Contact			Submission			Response
Submission No	Submitted on behalf of Group?	Submission Date	Nature of Submission?	Document Referenced	Submission Details	Council Comments/ Response
1	Local Resident	8/08/2022	Submission Form	Nepean River	The customer is suggesting that the risk of flooding at the Nepean River is far greater due to flood behaviour and climate change impacts. According to him - dredging of the Nepean River would substantially reduce the flood risk to property damage within the Camden area. In addition, the customer is suggesting to establish a Voluntary House Raising Scheme as part of the Floodplain Risk Management Plan that would allow residents to reduce the risk of damage to their property and possessions.	Dredging - Dredging of river channels does not prevent flooding during extreme river flows. It however impacts negatively through channel bed modification, habitat degradation, remobilization of contaminants, and increases in suspended sediment concentrations. It can disturb the natural balance of rivers which can lead to increased erosion, changes in the river geomorphology, destroying natural habitat, and impacts on flora and fauna. VHR Scheme - Voluntary House

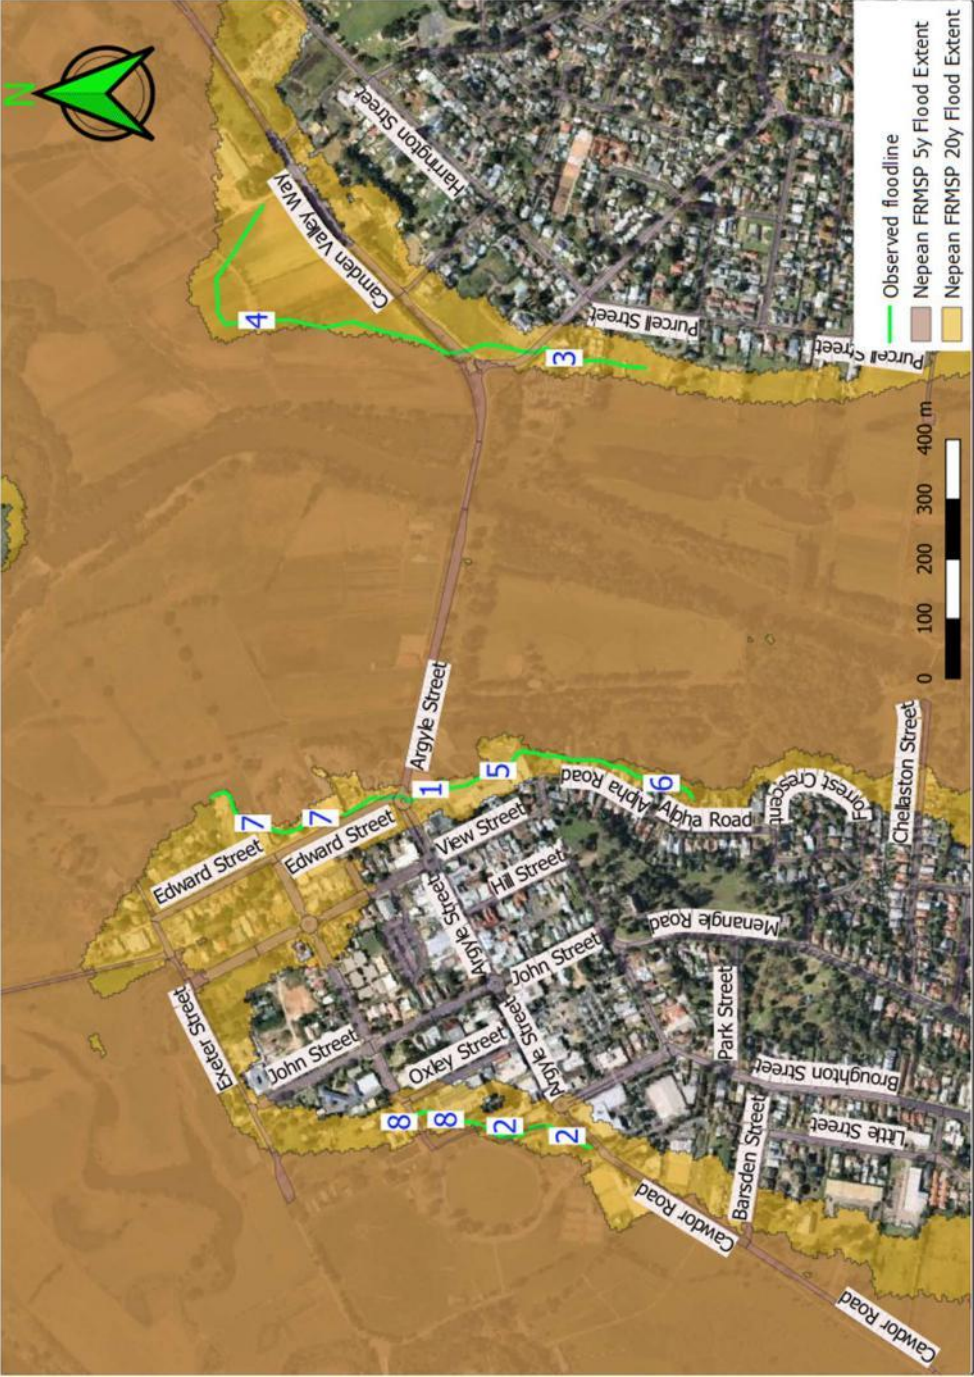
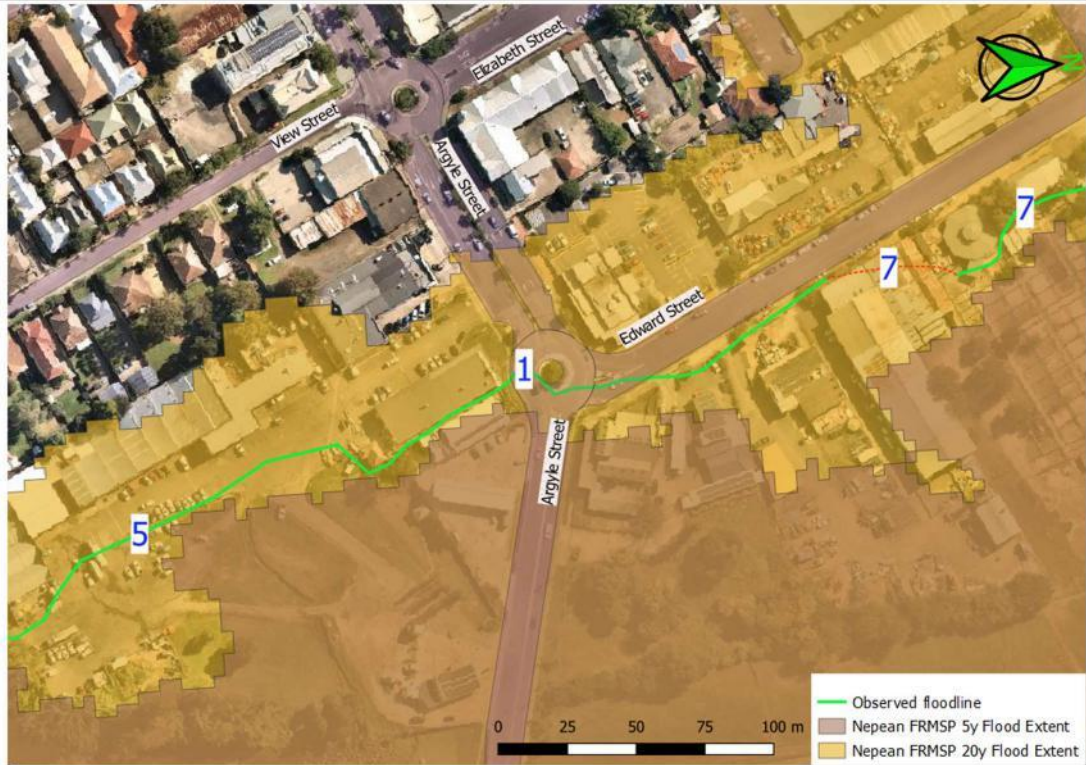
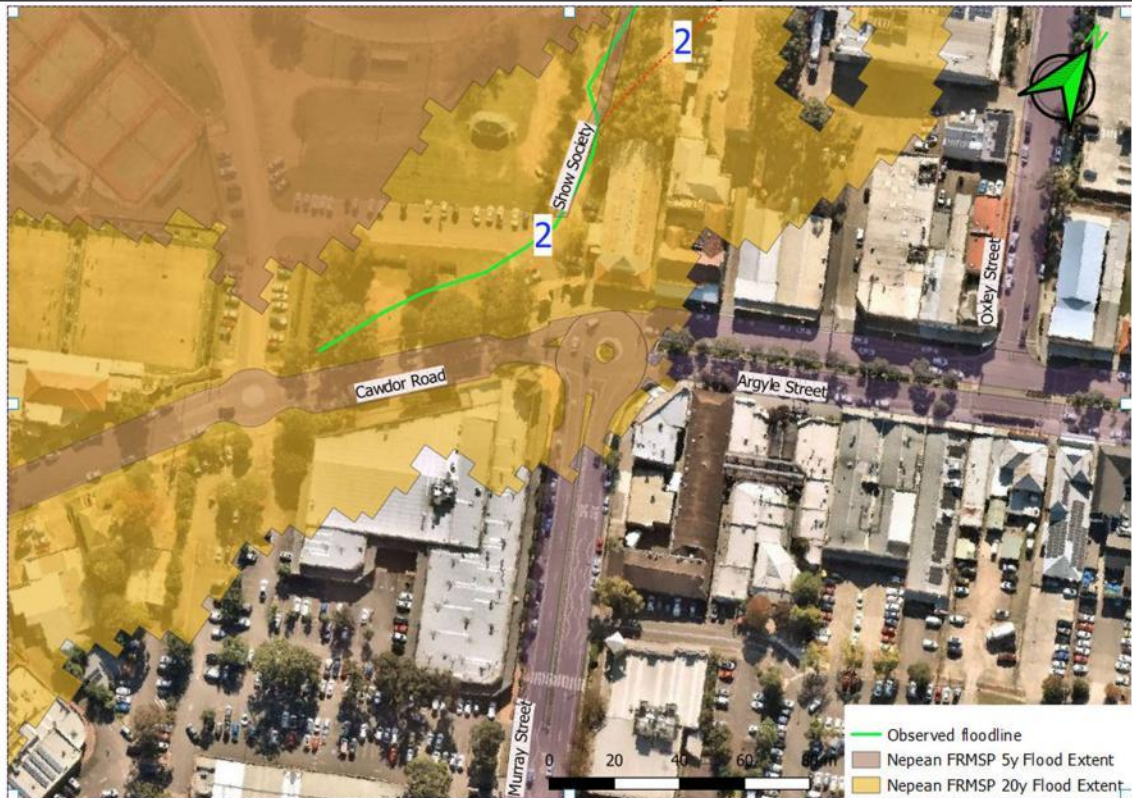
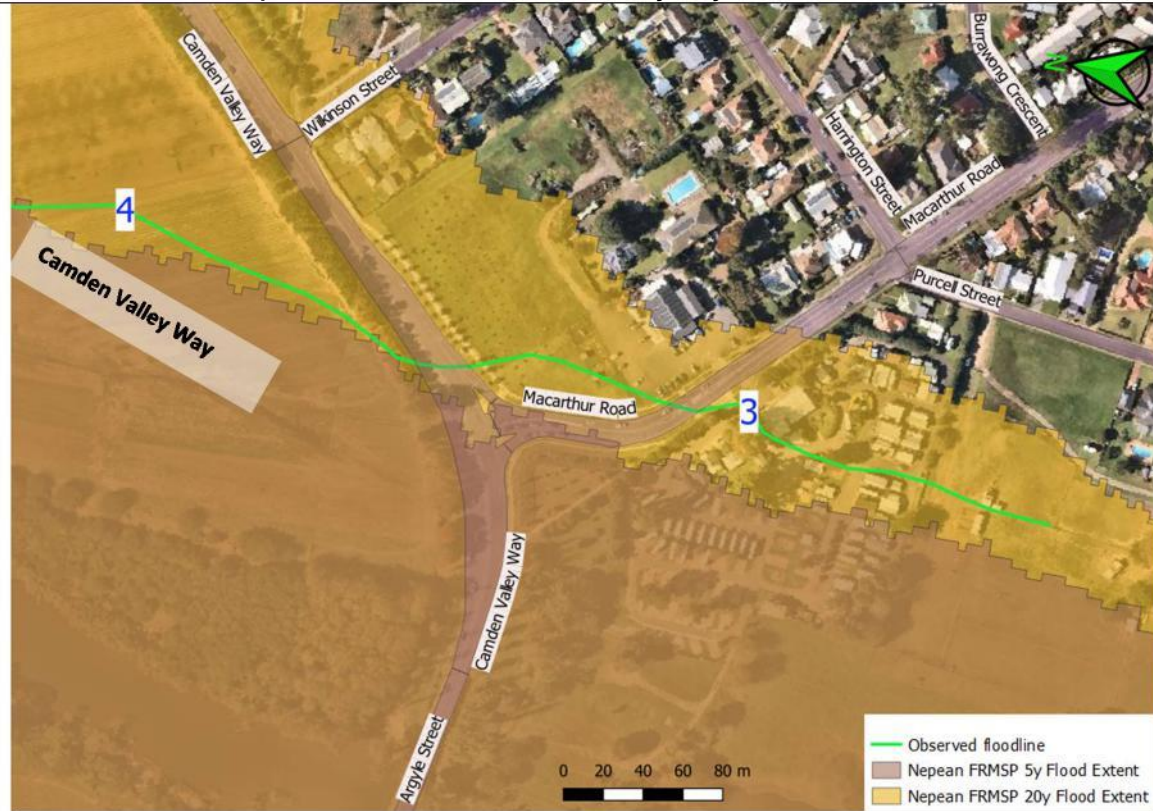
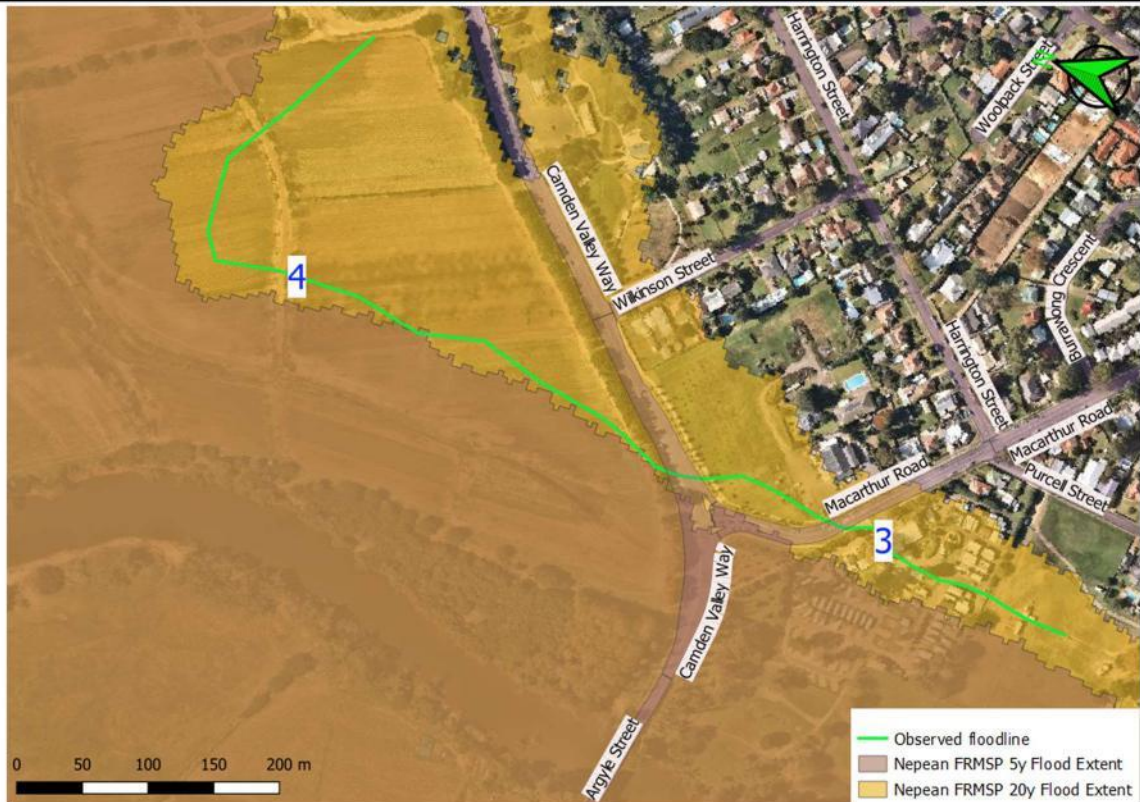
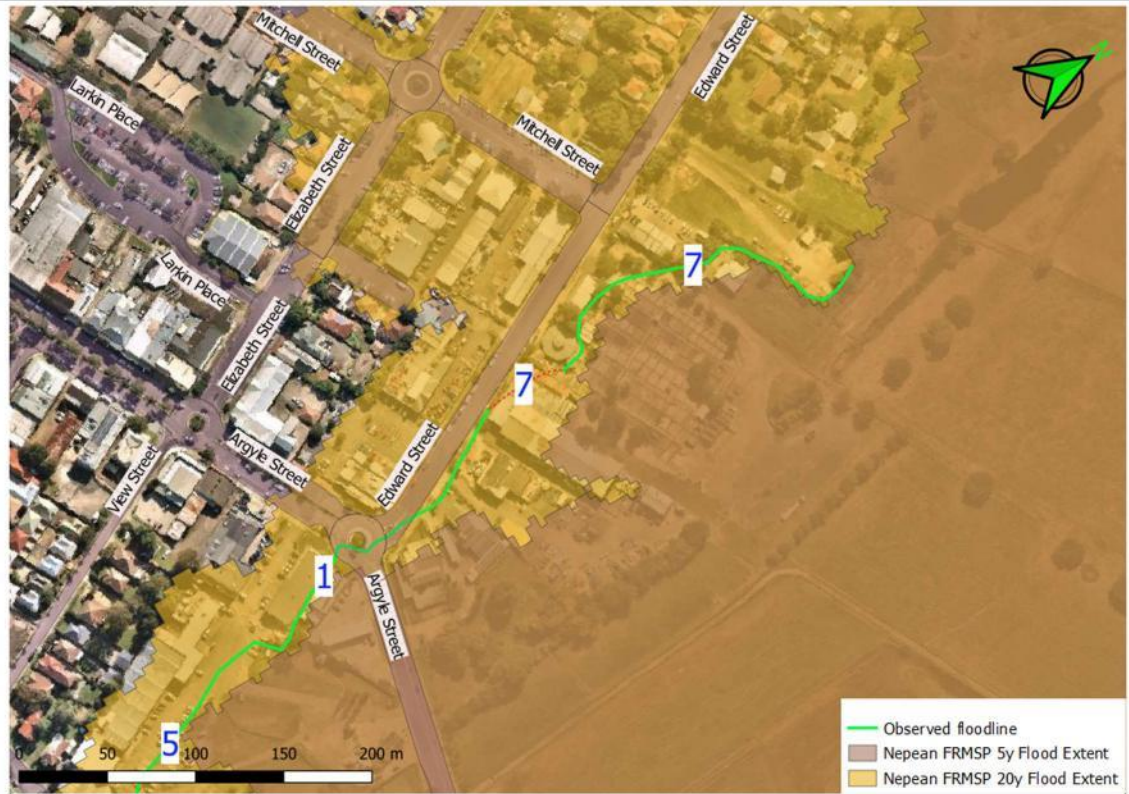
Based on historical flood data, the Cowpasture Bridge Gauge level of 12.3m corresponds to approximately an event closer and lower to 6.5 year.

The comparison of flood extents from March 2022 flood photos and the Nepean River FRMSP flood mapping shows that the flood extents are consistent with the flood event indicated from the gauge justifying the validity and the accuracy of the Nepean River FRMSP flood mapping.
